# UNITED STATES PATENT AND TRADEMARK OFFICE

APPLICATION NO.	FILING DATE	FIRST NAMED INVENTOR	ATTORNEY DOCKET NO.	CONFIRMATION NO.
10/767,211	01/28/2004	Frederick J. Dojan	005127.00275	2584
22909	7590	09/23/2005	EXAMINER	
BANNER & WITCOFF, LTD. 1001 G STREET, N.W. WASHINGTON, DC 20001-4597			KAVANAUGH, JOHN T	
			ART UNIT	PAPER NUMBER
			3728

**Office Action Summary**

**DETAILED ACTION**

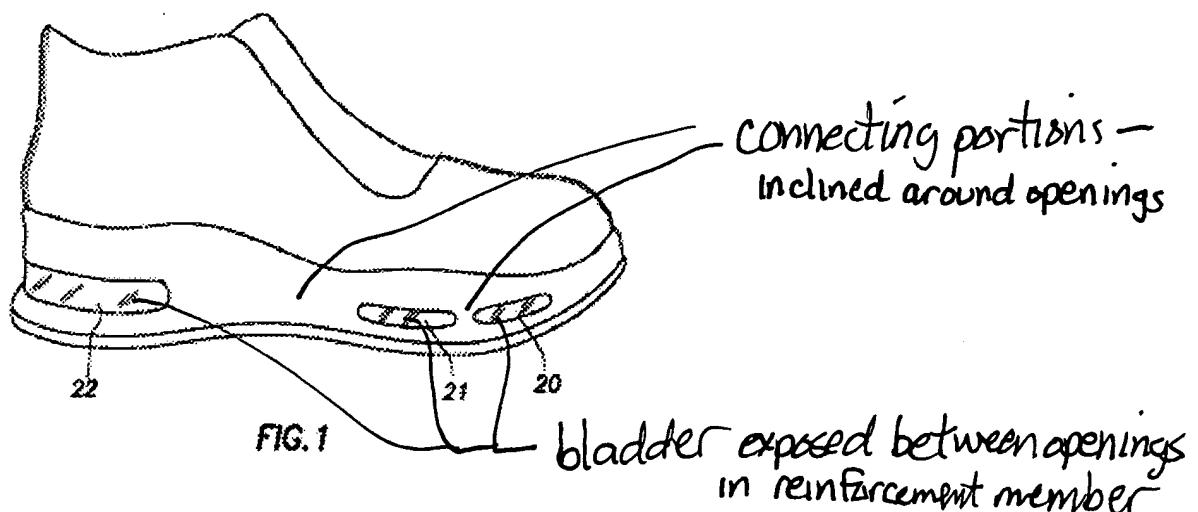
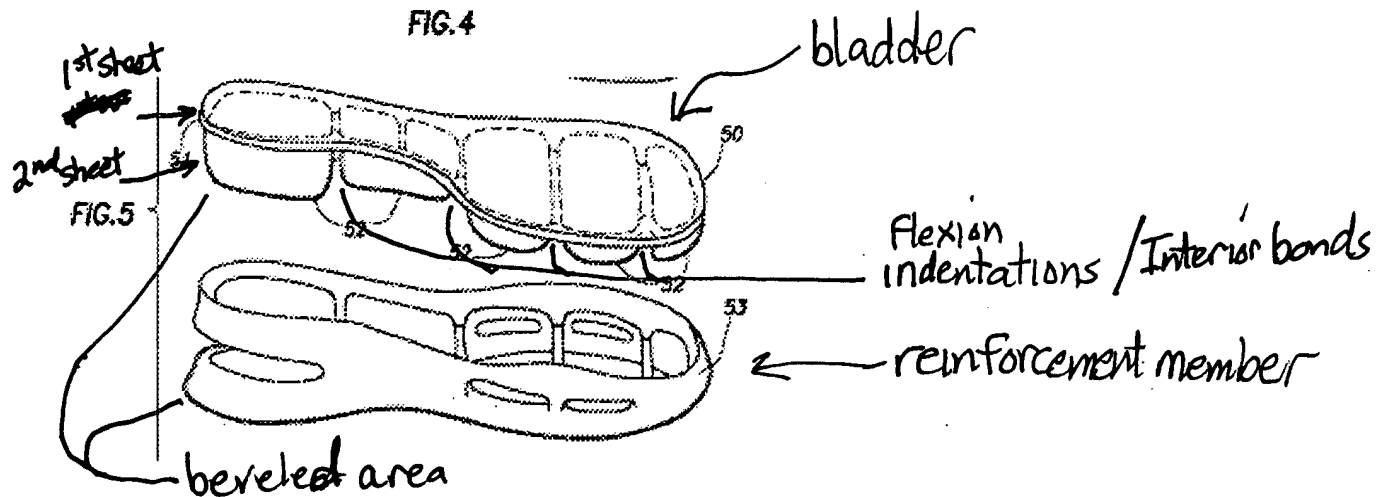
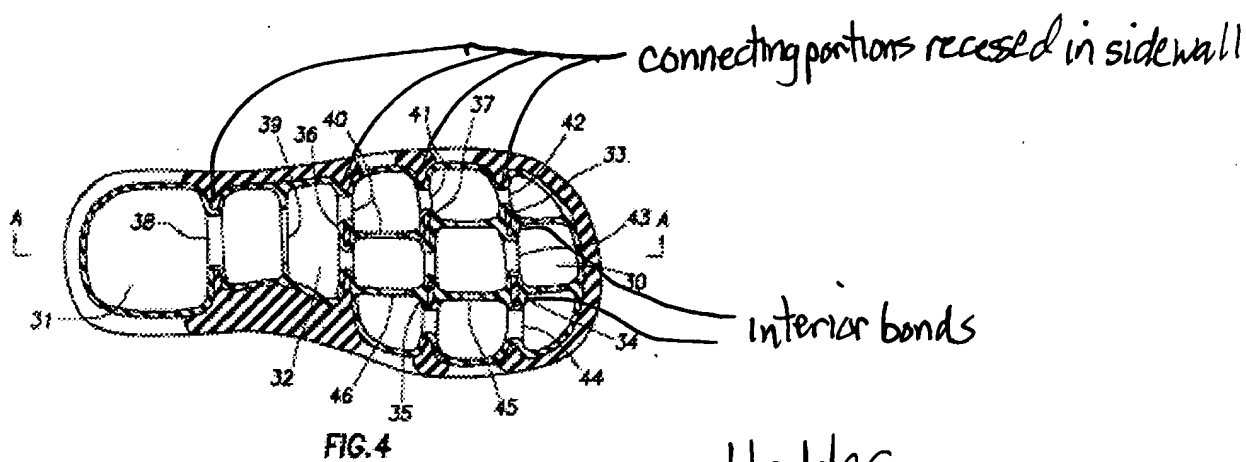
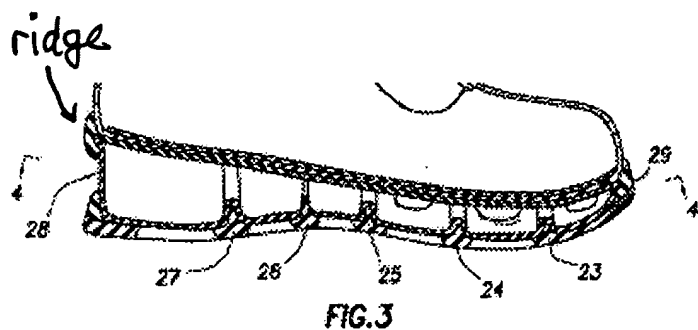
4. Claims 1,2,4-9,11,12,14,15,18-20,24,25,26,28-31,35,37-42,46-56,59,60-70,73-76,96-99 and 101-109 are rejected under 35 U.S.C. 102(b) as being anticipated by US 6009637 (Pavone). Pavone teaches an article of footwear comprising an upper and a sole structure as claimed; see the marked-up figures below. a sole component as claimed including a bladder and a reinforcing structure at least partially recessed into the barrier material as claimed. See the marked-up figures below. When the bladder is inflated to a certain point and/or there is a great enough force applied (i.e. the force created upon impact upon the wearer's foot) to the bladder, it will inherently place the connecting portions of the reinforcing structure in tension. When such a force is applied the sidewalls of the bladder will create an outward force and hence place the connecting portions in tension. Also, the reinforcing structure will inherently restrain distension of the surfaces of the bladder. Regarding claims 24 and 46, as understood, the outsole (54) of Pavone represent a second different material of the reinforcing structure.
